DOCKETE	Z D
Docket Number:	07-AFC-06C
Project Title:	Carlsbad Energy Center - Compliance
TN #:	203981
Document Title:	Carlsbad Energy Center Project Amendment FSA Supplement and CEC Staff Rebuttal Testimony
Description:	Supplement and Rebuttal
Filer:	Alexis Surita
Organization:	California Energy Commission
Submitter Role:	Commission Staff
Submission Date:	3/27/2015 2:17:00 PM
Docketed Date:	3/27/2015

ENERGY COMMISSION STAFF'S SUPPLEMENT TO THE FINAL STAFF ASSESSMENT AND REBUTTAL TESTIMONY

SUPPLEMENT TO THE FINAL STAFF ASSESSMENT

VISUAL RESOURCES - FIGURE 9

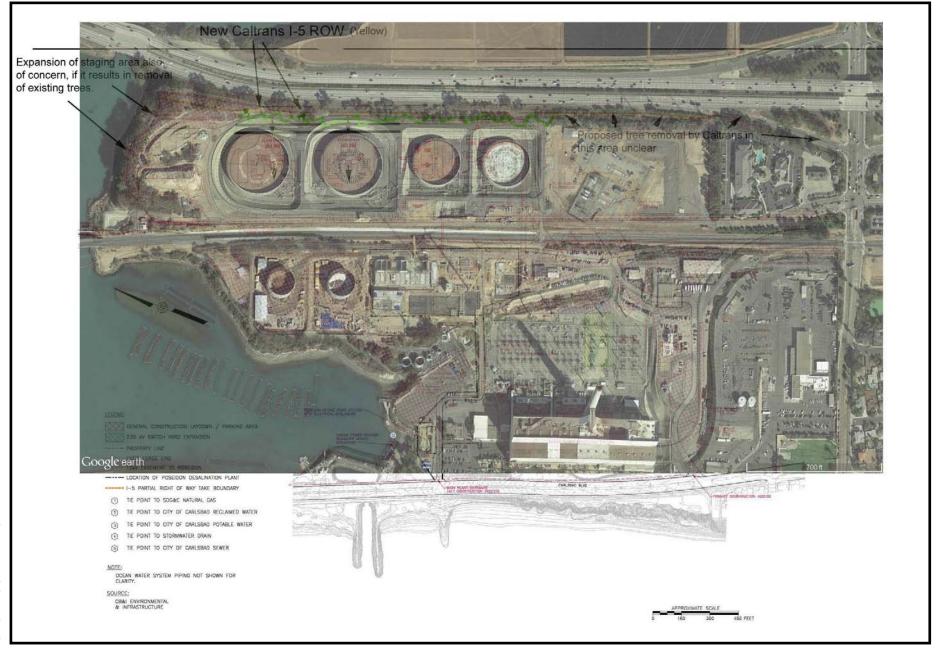
Finally, **Figure 9**, taken from the I-5 Project Design Guidelines, depicts Caltrans' landscaping intent along the CECP site. Contrary to statements provided in the POV opening testimony, which were based on informal conversations with Caltrans staff, the

plan clearly shows the original intent of the I-5 project to establish 'Category 1' (native) landscaping in the ROW of the project along the CECP site boundary. These measures from the Design Guidelines in effect constitute a component of the mitigation measures identified in the I-5 Project Final Environmental Impact Statement (FEIS) and its associated Visual Impact Assessment Technical Report. The cumulative impact of the (licensed) CECP project in combination with the I-5 Widening Project was recognized as a significant cumulative visual impact in the I-5 Project FEIS (p. 3.25-25, I-5 NCCP FEIS).

To address the concerns expressed by POV regarding visual impacts associated with the widening of I-5, staff proposes amendments to Condition of Certification VIS-5 as shown in the attached Appendix A. In addition, a modification to Condition of Certification VIS-1 is proposed by staff to correct the inadvertent omission of transmission poles from the measure, and to address concerns of intervenor POV about impacts of the transmission poles. The modification, also reflected in Appendix A, calls for color treatment of transmission poles as well as exhaust stacks.
